## Architectural Review Board Staff Report

**Description:** **Wildhorse Village, Lot 2A-2 (Terraces at Wildhorse Village) SDSP:** A Site Development Section Plan, Landscape Plan, Lighting Plan, Architectural Elevations and Architect's Statement of Design for a 3.6 acre tract of land zoned "PC&R" – Planned Commercial and Residence District located southwest of the intersection of Wild Horse Creek Road and Lakeview Terrace.

Re: Wildhorse Village Lot 2A-2

**Modification Request to City of Chesterfield Ordinance No. 3161**  
**Attachment A -Section IB.1-Building Floor Height**  
**Attachment A -Section IG.5 – Rooftop Mechanical Equipment Screening**

Figure 5: Building Materials

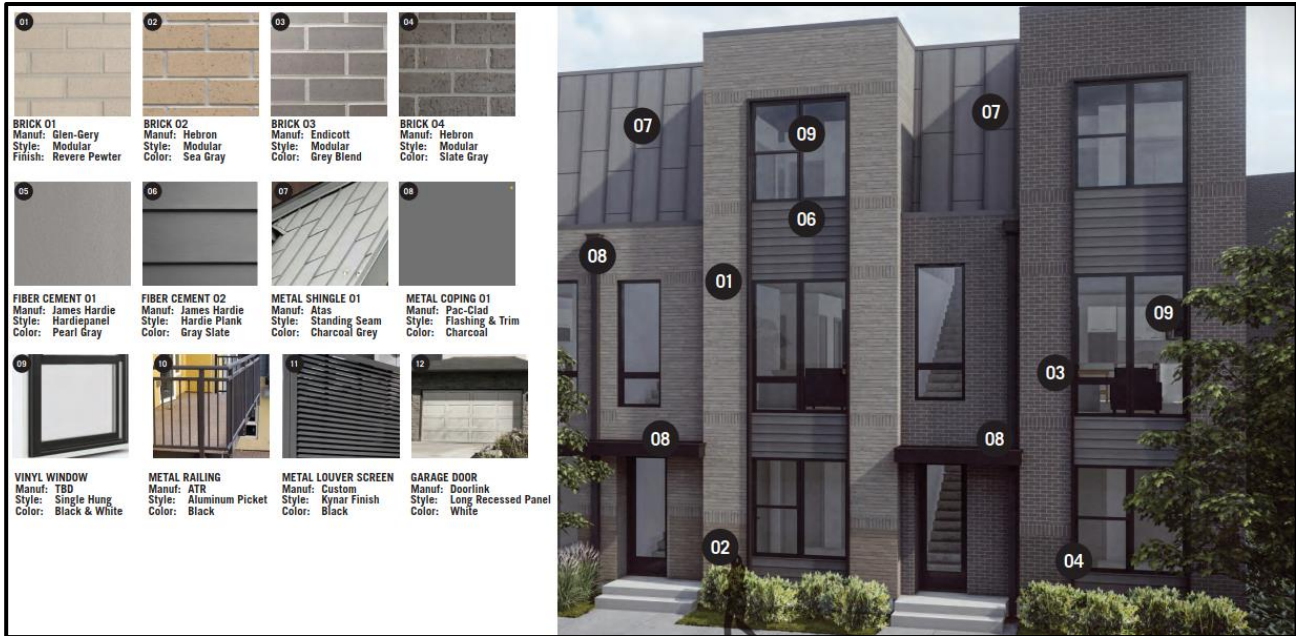
The building is primarily four different colors of brick on the front and rear with fiber cement on the rear. Fiber cement and metal shingles are also incorporated into the structures all in specific gray/slate color.

It should be noted that this is the same development team as the neighboring property to the west “The Flats at Wildhorse Creek”. Building material samples for both this project and The Flats building will be provided at the May 12<sup>th</sup> Architectural Review Board meeting as the applicant stated in the attached narrative statement; *“The warm color palette of browns and grays is intended to harmonize with the neighboring Flats at Wildhorse Village to feel calm and inviting”*.

# Building Sections

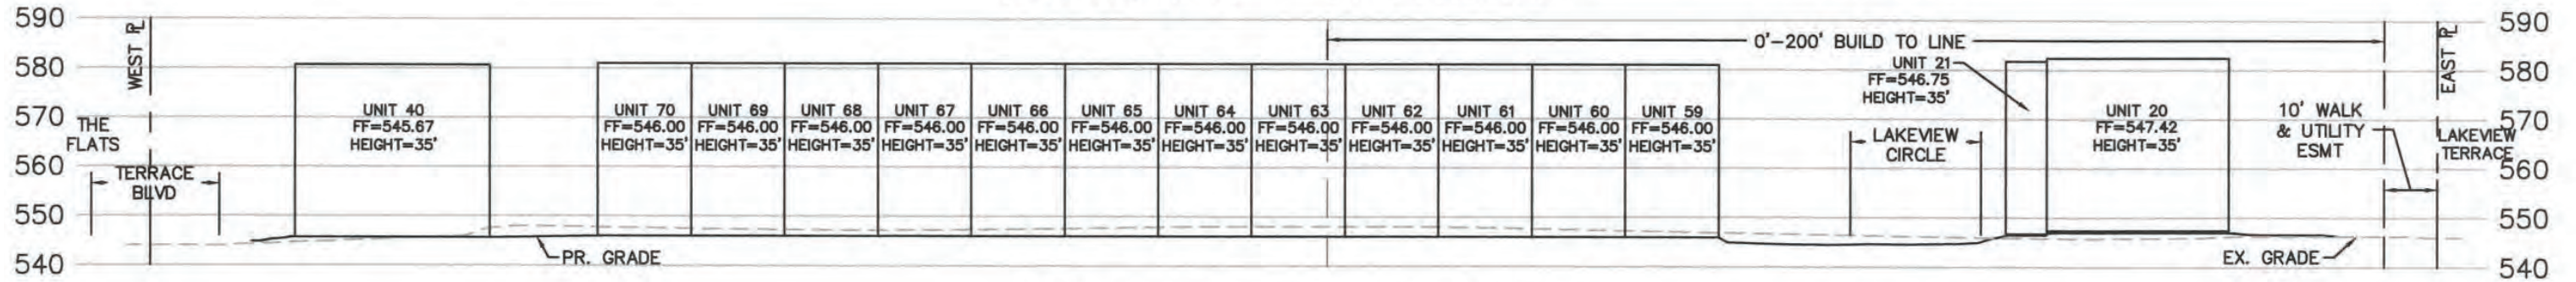
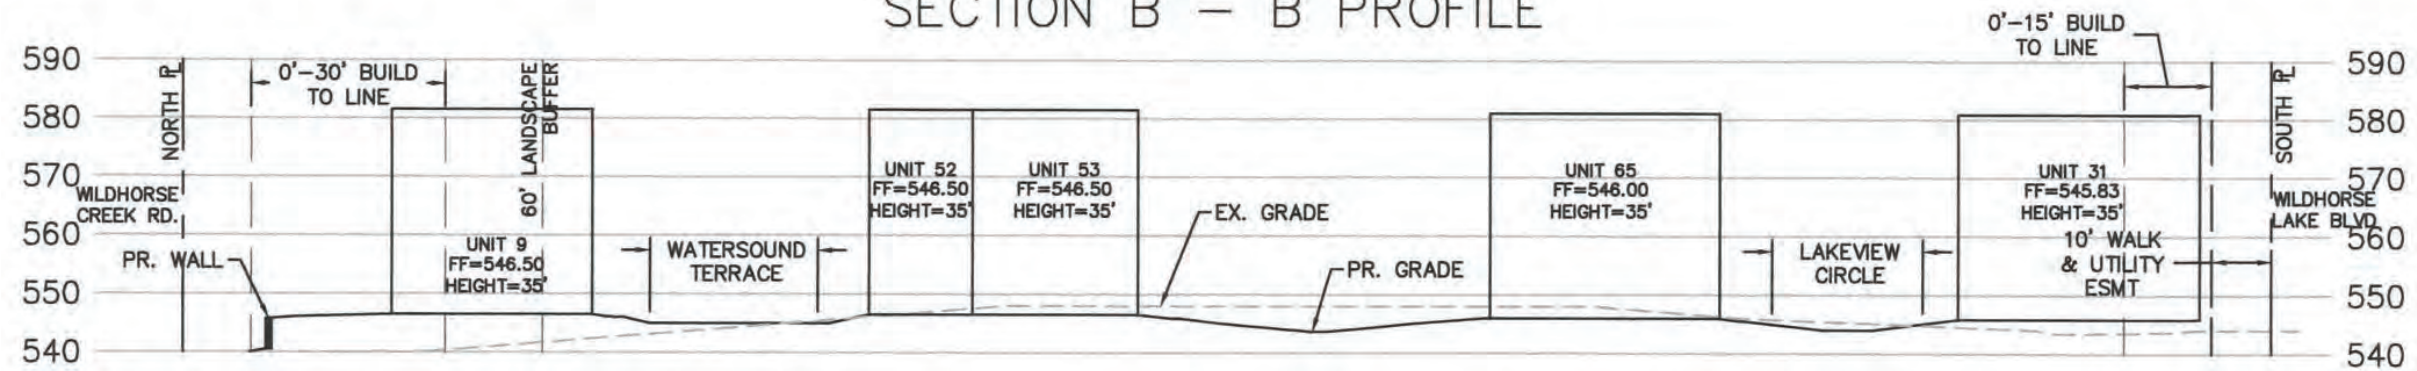
Section IB.1 of Ordinance No. 3161, states: “first story heights shall be 12-30 feet with the exception that the residential buildings in the geographic areas of Lots 1 and 6 on the Preliminary Development Plan shall be 9-30 feet.” We are proposing 10’-0” first floor height in lieu of 12’-0”. As designed, the first floor height uses precut dimensional lumber. In order to achieve 12’-0” as required by the ordinance, a significant amount of construction waste, time and money would be required to cut the studs down to size.
